# Easement Enquiry Design Advice

### Response to Easement Enquiry: 2020-023 – Modification to Oakdale West (SSD-7348-MOD-1)

#### Enquiry Details

Figure 3 – Clearance from Tower 107 to batter earthworks and bio-retention basin No.4

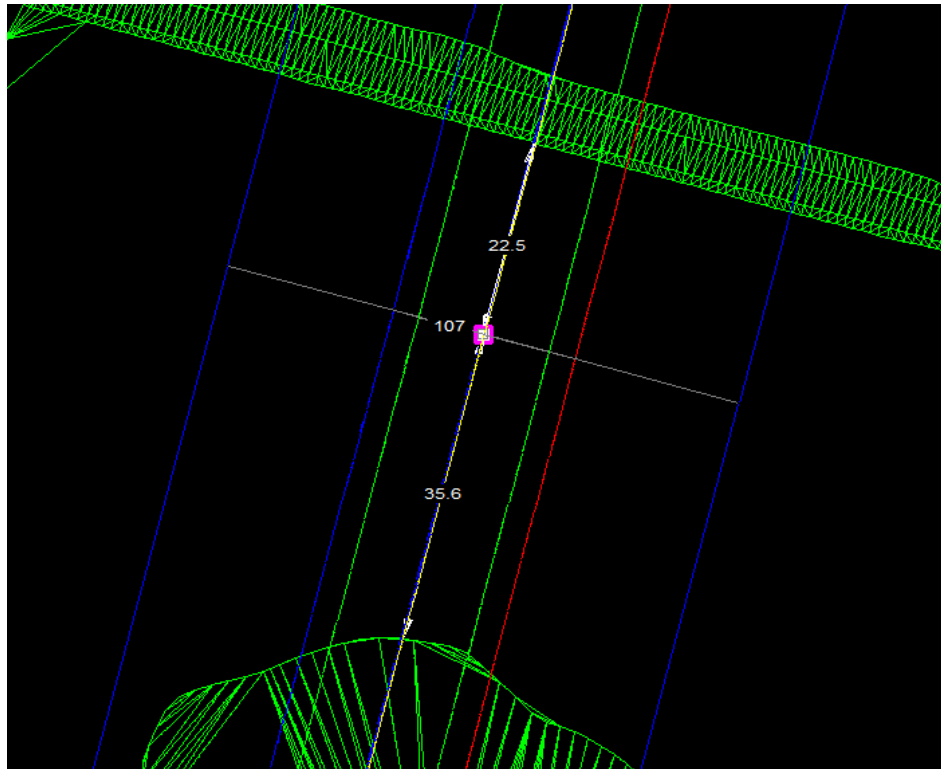
- Proposed ground has clearance to the 330kV aerial conductors at span of 106-107 of **TL14**, of 9.35m, where the conductor is sagged at maximum operation temperature of 120°C. This is compliant to AS/NZS:7000 clearances.
- Proposed ground has clearance to the 330kV aerial conductors at span of 107-108 **TL14**, of 8.76m, where the conductor is sagged at maximum operation temperature of 120°C. This is compliant to AS/NZS:7000 clearances.
- Structure Exclusion Zone;
  - To Tower 106 is 87.2m
  - To Tower 107 is 22.5m

Figure 4 – Clearance from Tower 9 to batter earthworks and bio-retention basin No.4

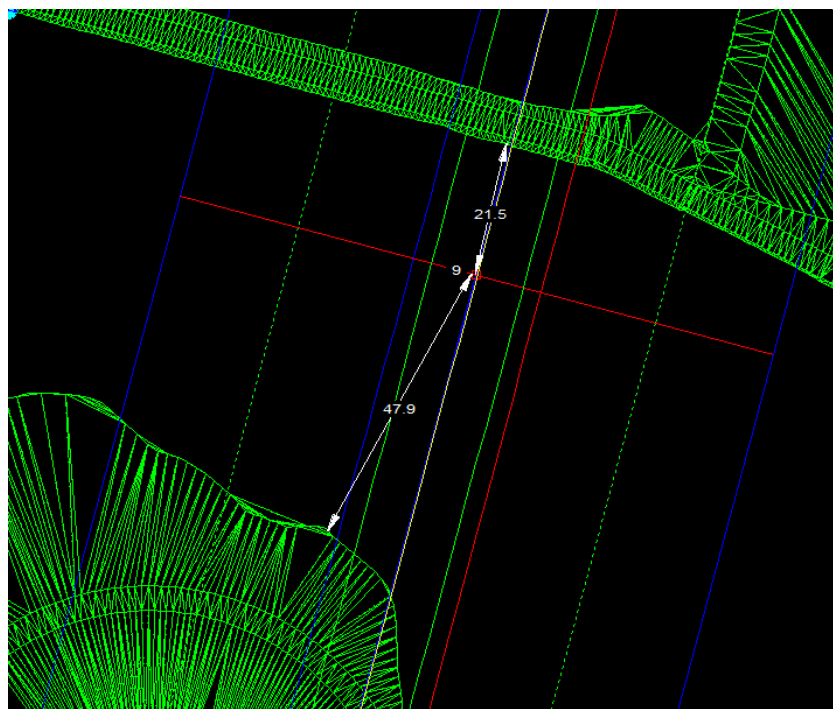
- Proposed ground has clearance to the 330kV aerial conductors at span of 8-9 of **TL30**, of 9.73m, where the conductor is sagged at maximum operation temperature of 120°C. This is compliant to AS/NZS:7000 clearances.
- Proposed ground has clearance to the 330kV aerial conductors at span of 9-10 **TL30**, of 8.85m, where the conductor is sagged at maximum operation temperature of 120°C. This is compliant to AS/NZS:7000 clearances.
- Structure Exclusion Zone;
  - To Tower 9 is 21.5mm to Lot 5A access road

Figure 5 – Clearance from Tower 8 to Lot 5A batter earthworks

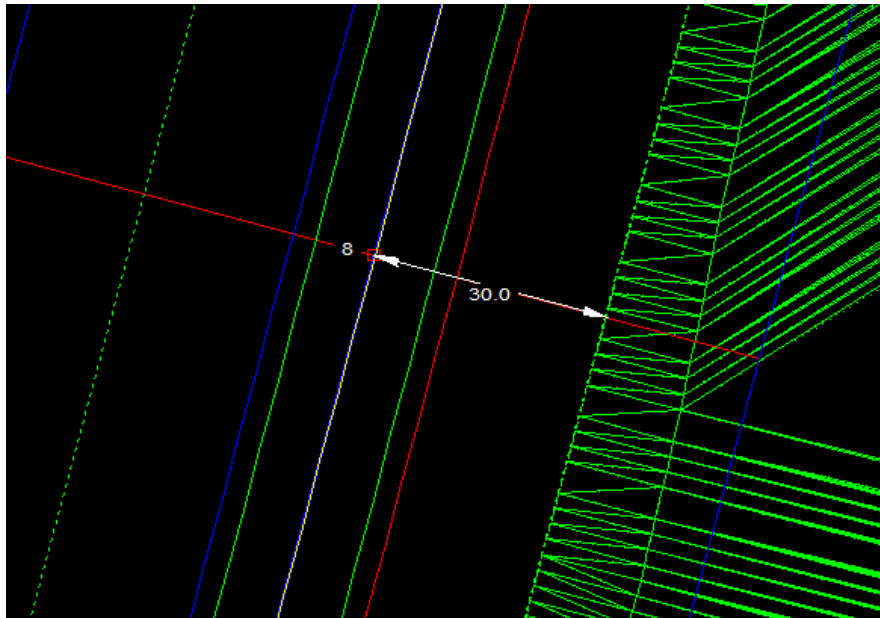
- To Tower 8 is 30m. Lot 5A batter is outside 20m structure clearance zone.
